425 N Frances & 450 W Gilman
Adjacency Recommendation
November 10, 2025

**MASSING, VISUAL HEIRARCHY, CONTEXT ALIGNMENT,
& PEDESTRIAN EXPERIENCE**

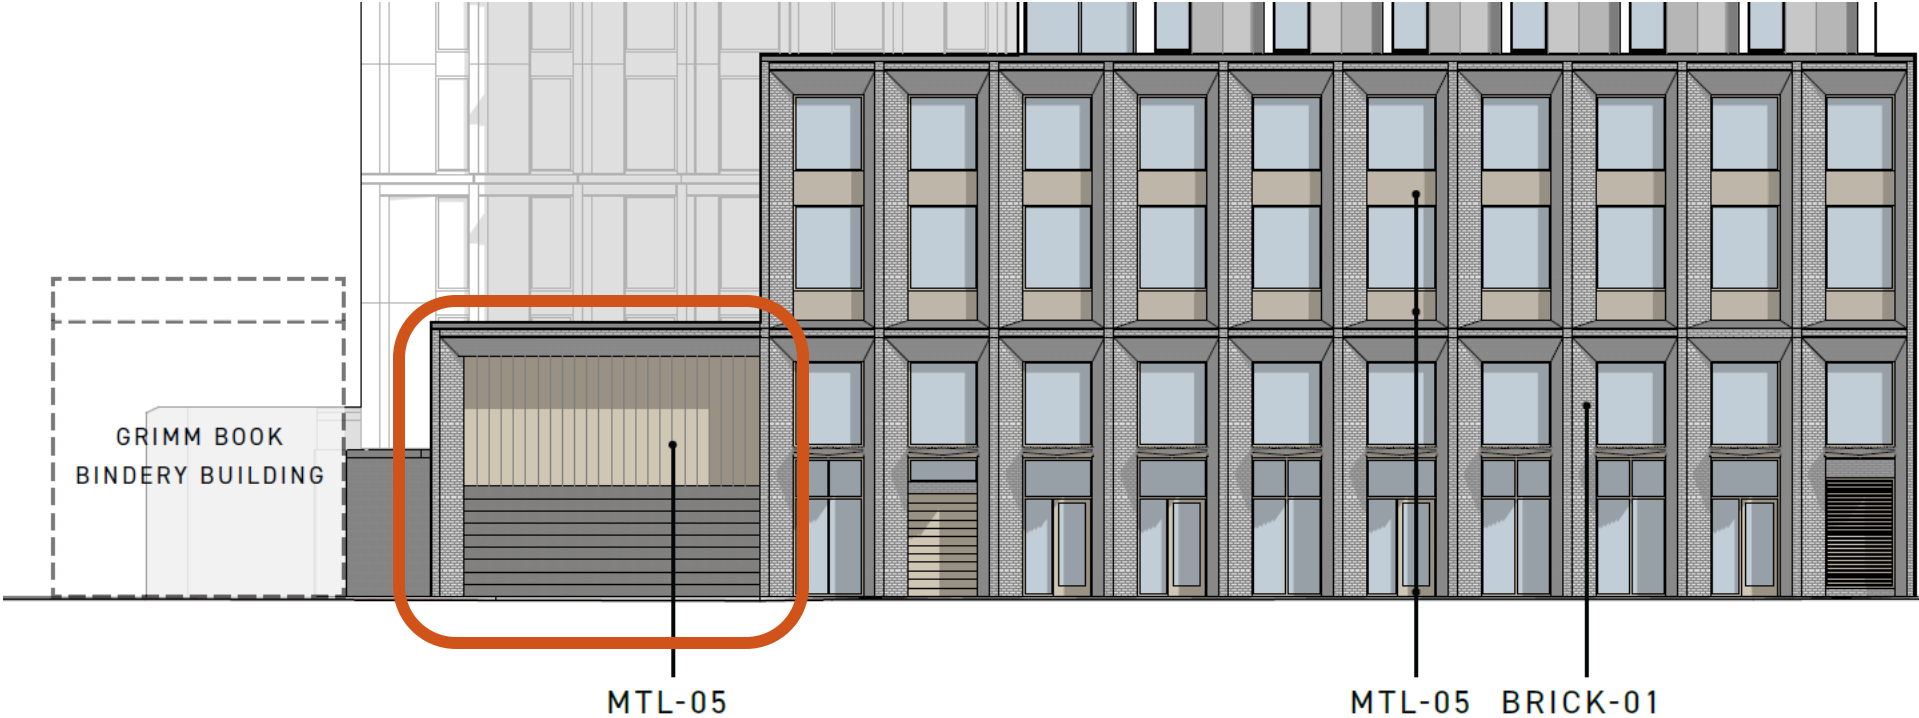
architectural disconnect. Staff would recommend a less industrial character to the area above the garage door and the door itself, so that it looks more in keeping with the architectural character of a commercial storefront. At the moment, it reads more like a back side to a building. A glass-panel garage door would continue the boxy theme of the new building, while also providing more of a sense of street activation. Such doors could look like this:

Staff recommends the Landmarks Commission advise the Plan Commission and Urban Design Commission that due to the side setback and substantial step back from the single-story wing of the building, the proposed work will not be so large as to adversely affect the historic character and integrity of the adjoining landmark. However, the Landmarks Commission recommends a less industrial and closed character of the exterior materials of the single-story wing to increase the street-level activation so that it is not so visually intrusive as to adversely affect the historic character and integrity of the adjacent landmark.
